Natural Resources Division

Project Review Summary

November 2025

PMCP-24-00000041- 75 PARK PLACE

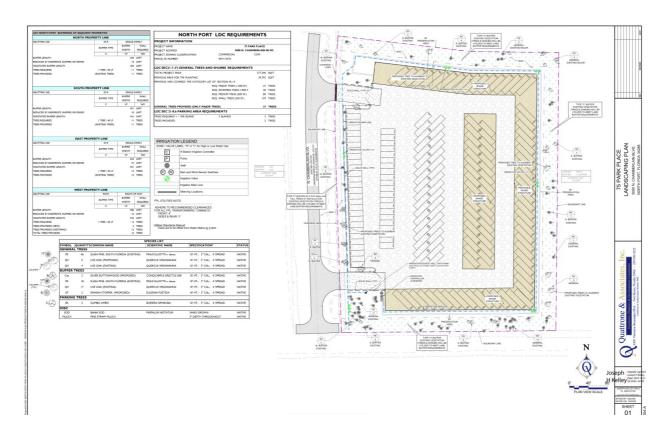
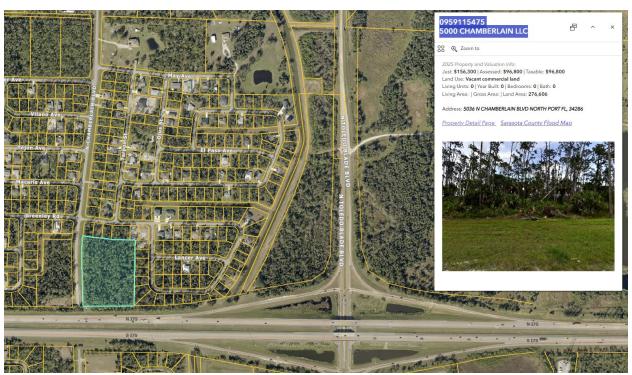
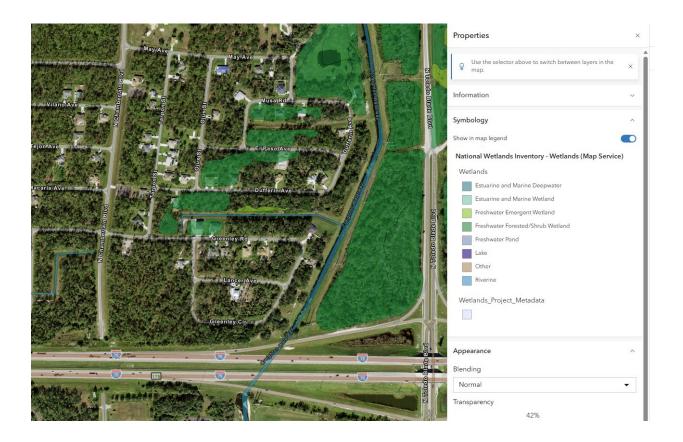
- 1. The tree survey indicates more trees than what is proposed for preservation on the site plans. During the Site Development Review, it is recommended to keep this buffer in its natural state. By doing so, there will be no need to plant additional trees to meet the requirements for a Type C buffer, as the existing trees will satisfy this criterion. All trees designated for protection should have a barricade installed around them, which must remain in place throughout the construction period to prevent any damage to the protected trees. Chapter 45- Tree Protection Regulations.

- 2. During the last review cycle, the requirement for including shrubs in the Type C buffer was not reflected in your most recent revision. A Type C buffer requires the planting of shrubs, along with one tree every 40 feet. Although the revised landscaping plans indicate that a Type C buffer will be provided, the landscape calculations do not account for any shrubs as proposed.

- a. At the time of the site development review, please ensure that shrubs are included in your landscaping calculations and on the plans. It is recommended to use Florida native vegetation. Sec. 21-9.

PSDP-25-02840 - Wellen Park MOB

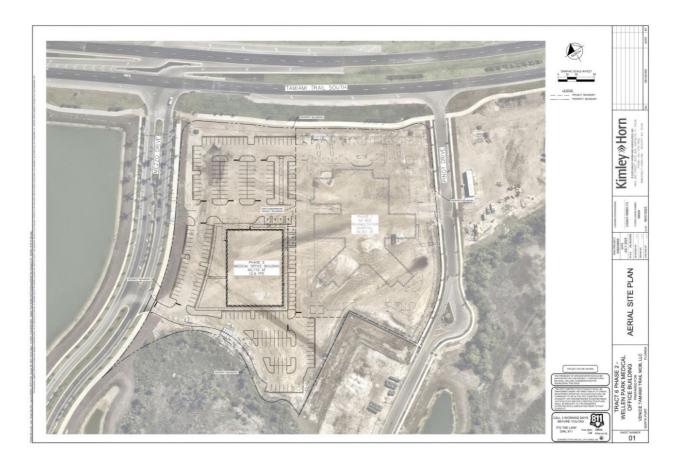
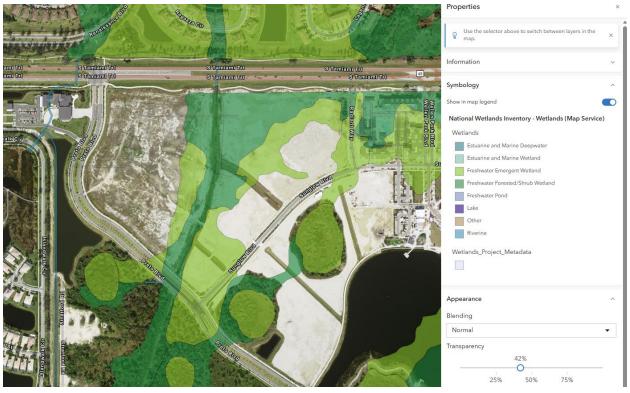
- 1. The applicant must plant all trees and landscaping in accordance with code regulations. They should follow the "right tree, right place" policy. No medium or large canopy trees should be planted within 20 feet of overhead utilities. Trees classified as small may be planted adjacent to power lines, with a recommended six-foot setback. Palms that can grow taller than 10 feet must be placed with a setback equal to their maximum frond length plus 3 feet.

- 2. A root barrier must be installed when a tree is within 10 feet of any street, sidewalk, driveway, underground utilities, or structure (see Section 4.3.2).

- 3. The property owner or their successor is responsible for maintaining all landscaping materials in a healthy condition, as approved, indefinitely. They must also replace any landscaping materials that are damaged, diseased, dead, or considered hazardous (see Section 4.3.1).
